ALERT SERVICE BULLETIN

DOORS - Sliding doors
Addition of a label on the sliding door cover

Revision No.	Date of issue
Revision 0	2020-06-18

[ASB AS350-52.00.53](#)

Figure 1

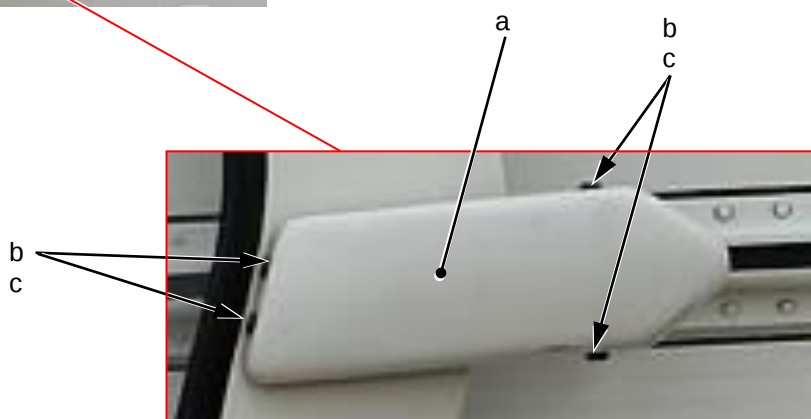
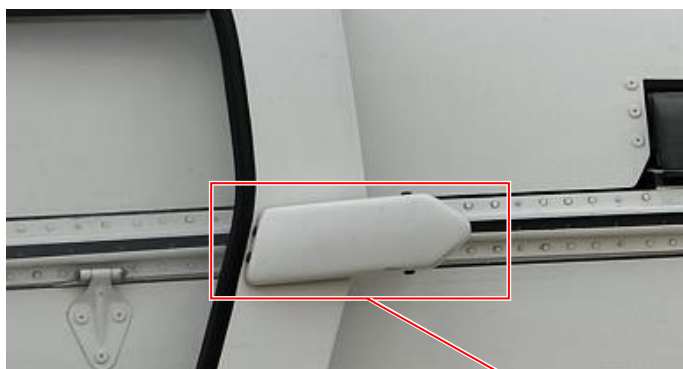
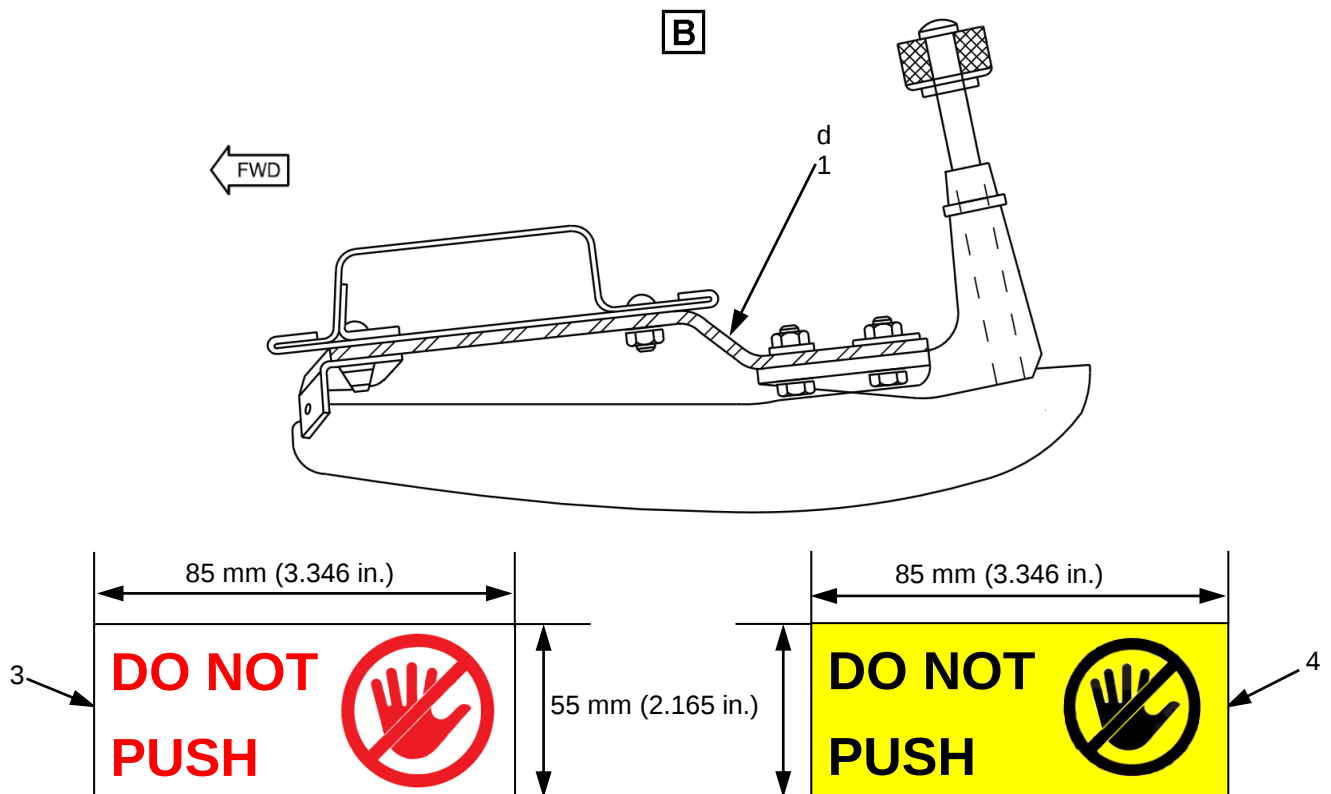
3.B.2.a. Removal of the cover (a), (Figure 1)

- Remove the screws (b) and the washers (c) ([Figure 1](#))
- Remove the cover (a).

- Remove the locally made label from the cover (a), if necessary.
- Install the LH rear support cover (a), ([Figure 1](#)).
- Install the washers (c) and the screws (b).
- Tighten the screws (b).
- Install the locally made label (3) or (4) on the LH rear support cover (a) as per Detail C, [Figure 2](#).

Figure 2

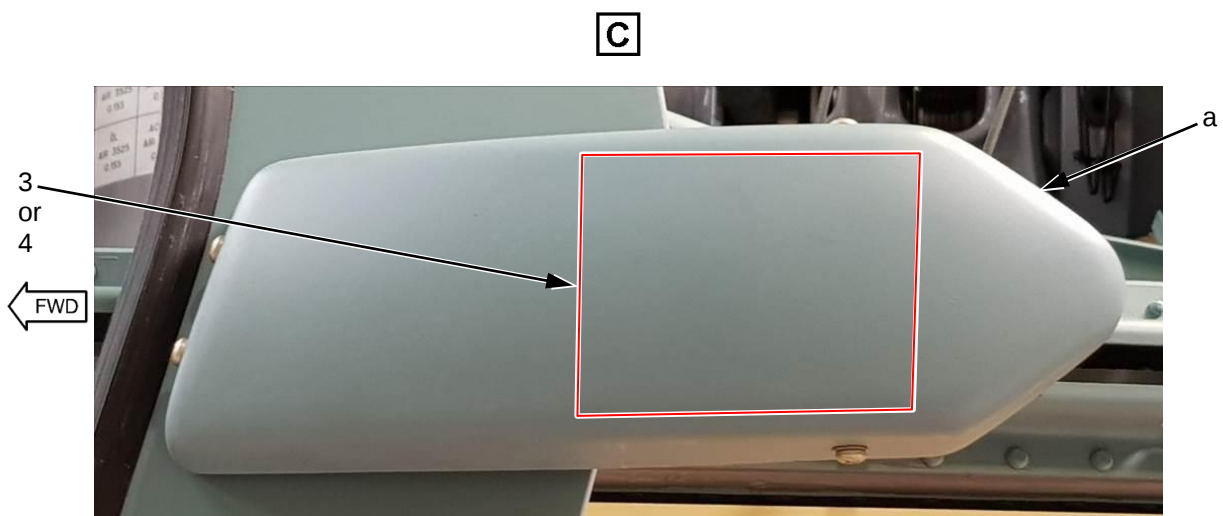
3.B.2.b. Check of the LH rear support (d) (Figures 2 and 3)

- Make sure that there is no crack on the LH rear support (d) ([Figure 2](#)).
 - . If there is no crack on the LH rear support (d):
 - .. install the cover (a) as per paragraph 3.B.2.d.
 - . If there is a crack on the LH rear support (d):
 - .. replace the LH rear support (d) as per paragraph 3.B.2.c.,
 - .. if the LH rear support (1) is not available:
 - ... flights are authorized until receipt of the LH rear support (1) if the door is kept closed,
 - ... bond a locally made label "DO NOT OPEN IN FLIGHT" (5) or (6) ([Figure 3](#)) to the inside of the LH sliding door so that the label is visible and legible to passengers,
 - ... on receipt of the LH rear support (1) install the LH rear support (1) as per paragraph 3.B.2.c.

- Remove the LH rear support (d), ([Figure 2](#)) as per the principles of Task 52-12-00, 4-3 (AMM) or Work Card 52-91-00-403 (MET).
- Install the LH rear support (1) as per the principles of Task 52-12-00, 4-3 (AMM) or Work Card 52-91-00-403 (MET).
- Remove the label "DO NOT OPEN IN FLIGHT" if previously installed.
- Install the LH rear support cover (a) as per paragraph 3.B.2.d.

The letter size takes into account the label integration on the LH and RH covers. Choose a size of letters that will be clearly visible to the ground technician or ground crew. Red letters on white background for civil versions.

The letter size takes into account the label integration on the LH and RH covers. Choose a size of letters that will be clearly visible to the ground technician or ground crew. Black letters on yellow background for military versions.
